PLANT NAMES: Oconee Nuclear Station

Re: Docket Nos. 50-269, -270, and -287

DUKE POWER COMPANY
 OCONEE NUCLEAR STATION
 CONSEQUENCES OF MAIN STEAM & FEEDWATER PIPING RUPTURE
 CURRENT STATUS OF DESIGN ENGINEERING REVIEW
 12-29-72

POSSIBLE MODIFICATIONS TO PENETRATION ROOM
12-29-72 PO-222

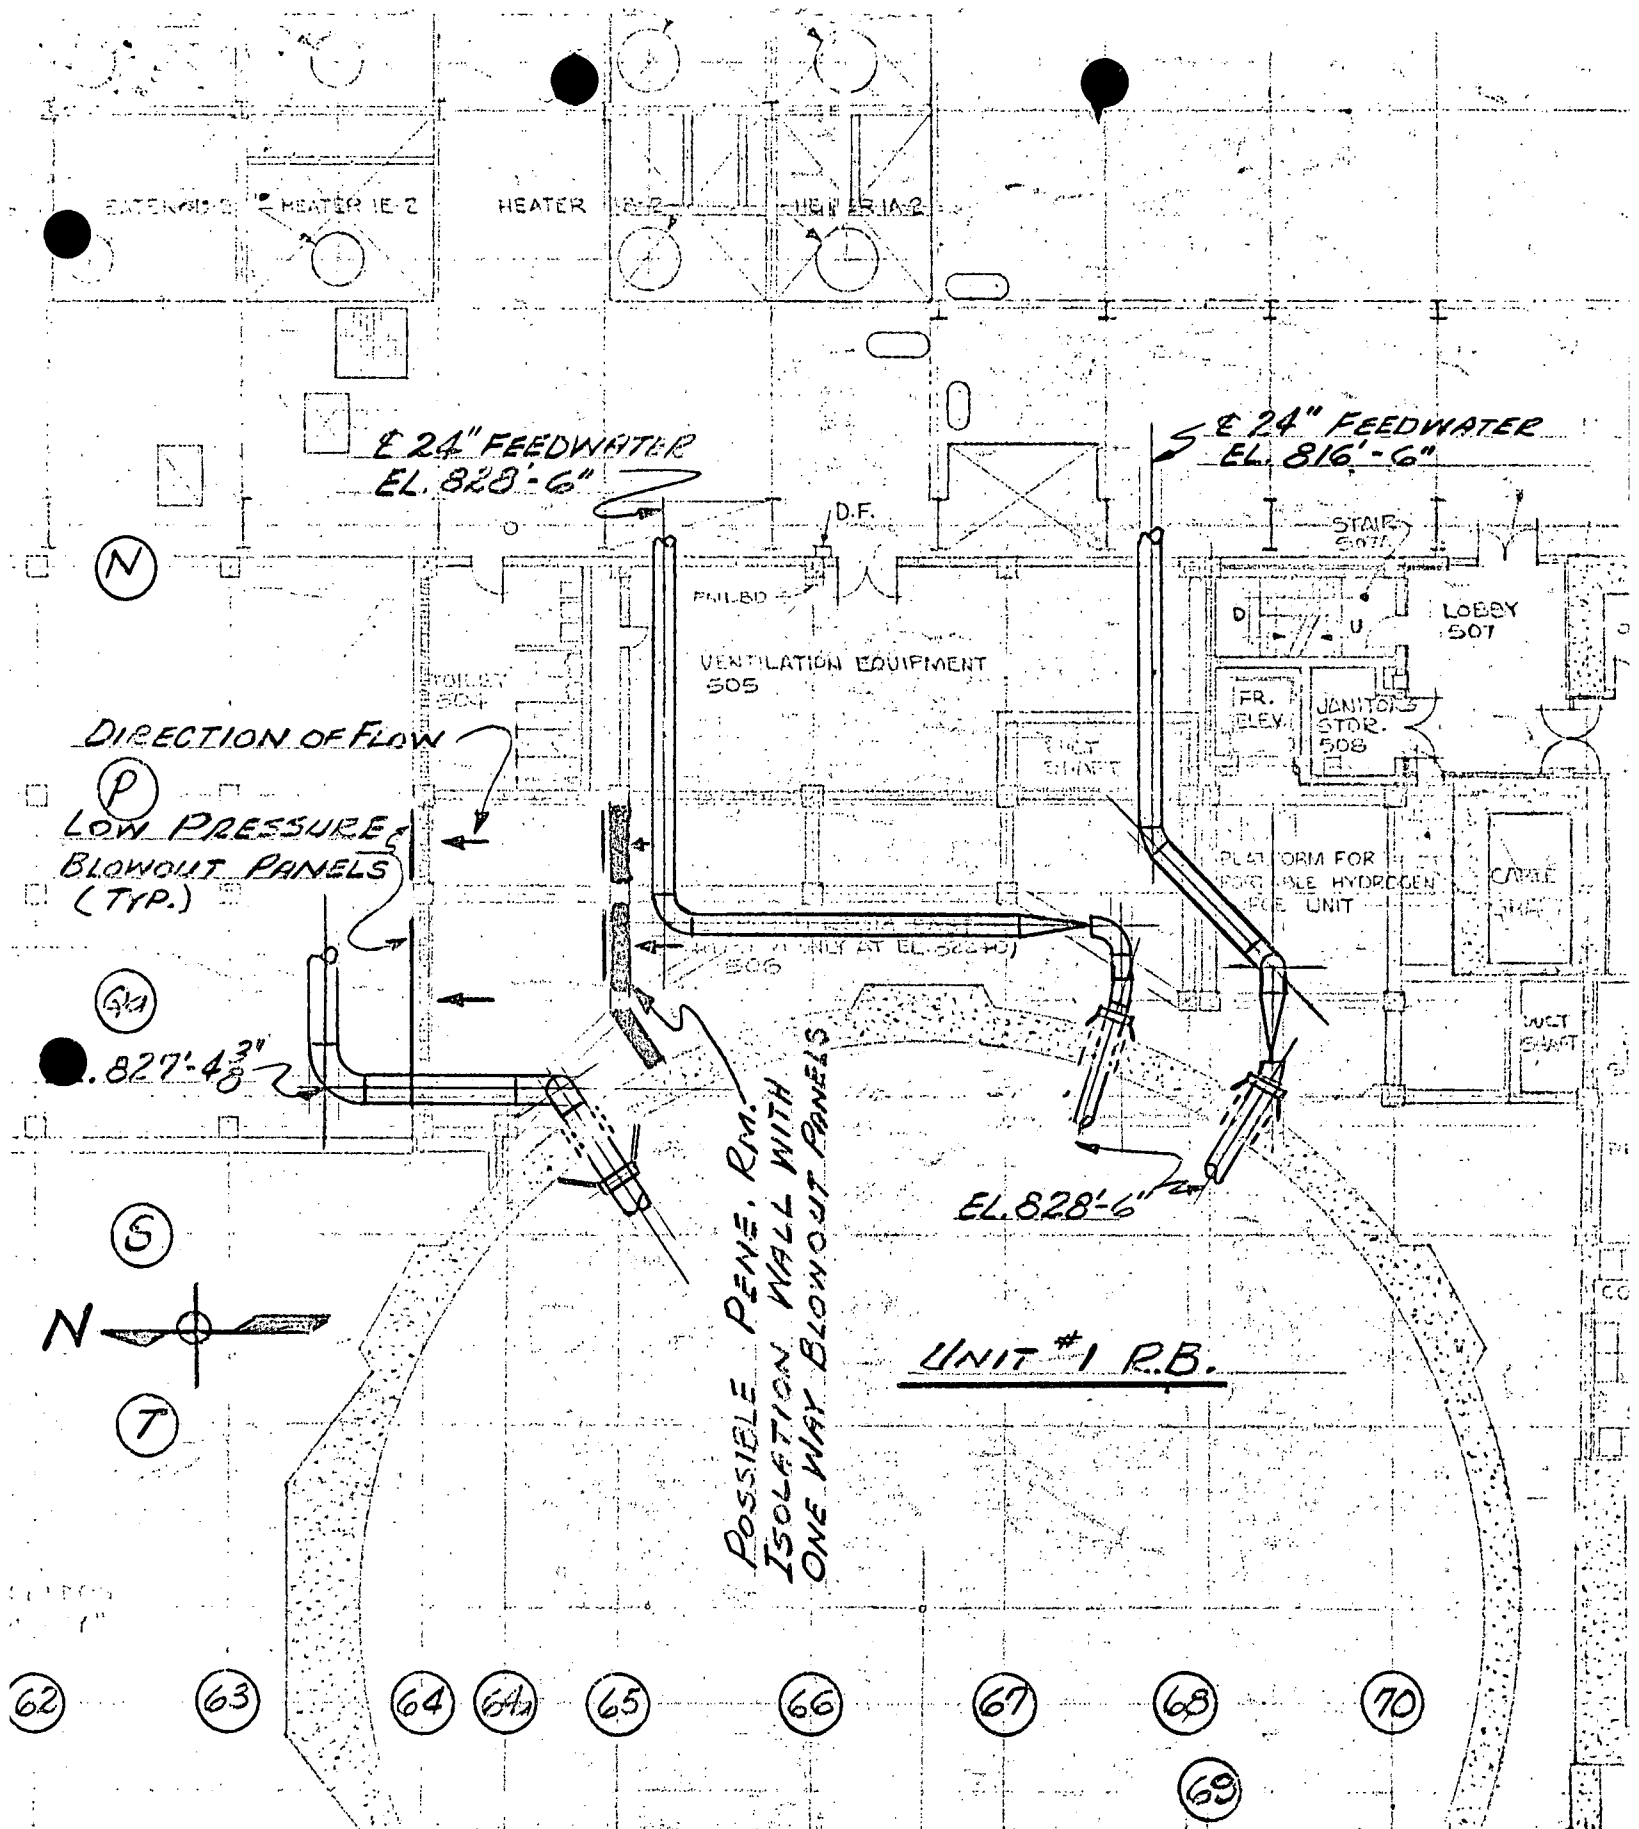
- b. East Steam Generator Main Steam Line. This line leaves the Reactor Building wall and passes through one corner of the East Penetration Room as shown on attached Sketch P0-222. Postulated pipe whip, jet impingement or reaction forces resulting from failure of this line would not damage any equipment necessary to shut down safely and maintain the reactor in a safe shutdown condition. However, pressure effects and steam concentrations might possibly pose a problem in the penetration room.

- c. East and West Main Feedwater Lines. These lines enter the Reactor Building through the East Penetration Room as shown on attached Sketch P0-222. Postulated failure of either of these lines could damage several auxiliary systems and related electrical components due to pipe whip, jet impingement and reaction forces. Feedwater for secondary side cooling is assured to the unaffected Steam Generator by either the steam-driven Emergency Feedwater System or the backup Auxiliary Service Water System. Pressure effects and steam concentrations could pose a problem in the penetration room. Since the postulated failure can occur on either the upstream or the downstream side of the Reactor Building isolation check valve, both cases are being analyzed.

At present, possible modifications to the station to reduce the effects of pressure and steam concentrations as described in 4)b. and 4)c. to acceptable limits are being analyzed.

- a. East Steam Generator Main Steam Line. As shown on the attached Sketch PO-222, the existing north penetration room wall may be modified to include low pressure blowout panels to relieve pressure and to provide a steam escape route for the postulated failure of this line. The addition of a new wall to remove the main steam line from the penetration room environment may be added along Column Line 65 as shown on Sketch PO-222.
- b. East and West Main Feedwater Lines. One way low pressure blowout panels may be added to the new wall along Column Line 65 to relieve pressure and provide a steam escape route for the postulated failure of these lines.
